**In the Matter of the Appeal of the ) FILE NO: LU 16-159330 LDS EN**  
**Hearings Officer's Approval of )**  
**EVERETT CUSTOM HOMES, INC.'S )**  
**Application for Subdivision Approval )**  
**and Environmental Compliance )**  
**Review )**  
**(Type III Proceeding) )**

**HAYHURST NEIGHBORHOOD  
ASSOCIATION'S MEMORANDUM  
IN OPPOSITION TO 11-LOT  
SUBDIVISION, AS PROPOSED**

**Date:** March 7, 2017  
**To:** Hearings Officer  
**From:** Stephanie Beckman, Senior Planner, Land Use Services  
Phone number: 503-823-6979  
**Re:** LU 16-159330 LDS EN, EVERETT HEIGHTS SUBDIVISION

Aerial map of site with GPS location of springs

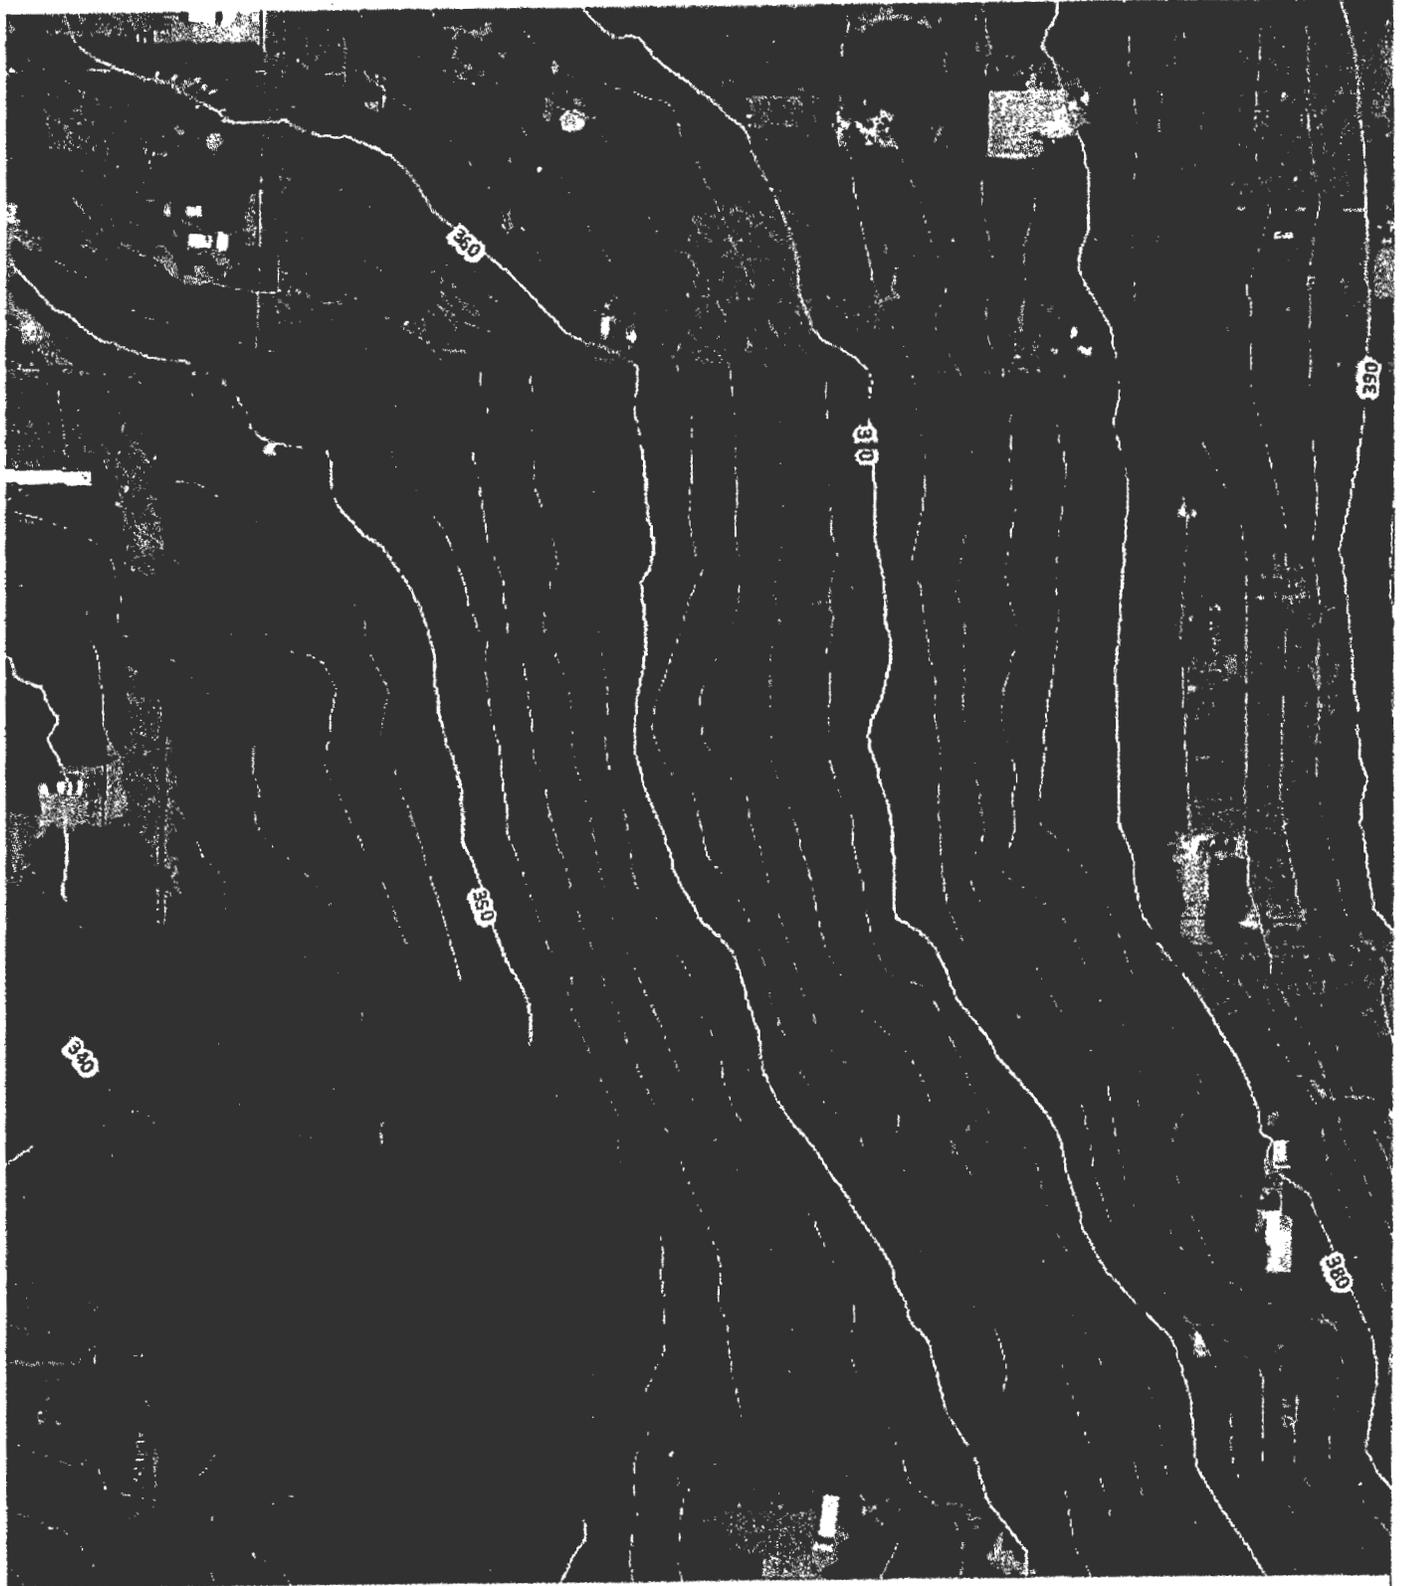
An additional site visit was conducted on March 1, 2017 in response to phone calls and emails from neighbors to Bureau of Environmental Services staff with concerns about water resources on the site. At that site visit, springs were identified by BES staff and located using a hand-held GPS device (see attached email and map). Based on this information, it appears as though some of the identified springs are outside of the environmental conservation overlay zone boundary, and therefore may be subject to the regulations of 33.640. However, as noted by BES staff, the accuracy of the GPS device is not exact and it is recommended that the applicant provide a surveyed location to determine where the springs are located.

During our sight visit on March 1<sup>st</sup> 2017, I noticed several springs flowing toward the delineated wetland. This spring flow and low depth to groundwater are likely what provides the hydrology for the wetland. I used a Trimble GPS to map the location of the springs. It appears that a majority of the springs are either within the wetland or within the environmental tract with the exception of three springs. Two of these three springs were not flowing and were located within a test pit the applicant said was dug for infiltration testing. It appeared these two springs had enough flow to scour soils from beneath adjacent vegetation roots. But it is not clear whether those springs would have presented as surface water if the test pit were not dug in that location. The springs may have instead remained under ground and as groundwater flow. The third spring however, was flowing at the time of the site visit. I took a video of the flow and mapped its location. Please see the attached map. What is unknown is the accuracy of the GPS point. Since the spring location is so critical for this development, the applicant may need to have the spring(s) professionally surveyed, which would get it to sub-centimeter accuracy. If so, I can go back out to the site and flag the location of the spring(s).

- Survey the location of identified seeps in the field to determine if they are within or outside of the environmental overlay zone;
- Provide an evaluation by a qualified professional as to whether the identified features must be preserved based on the regulations of 33.640 and, if so, the appropriate location of the tract boundary and limit of disturbance; and
- Update the plans and other materials as needed to respond to any changes required to the site plan.
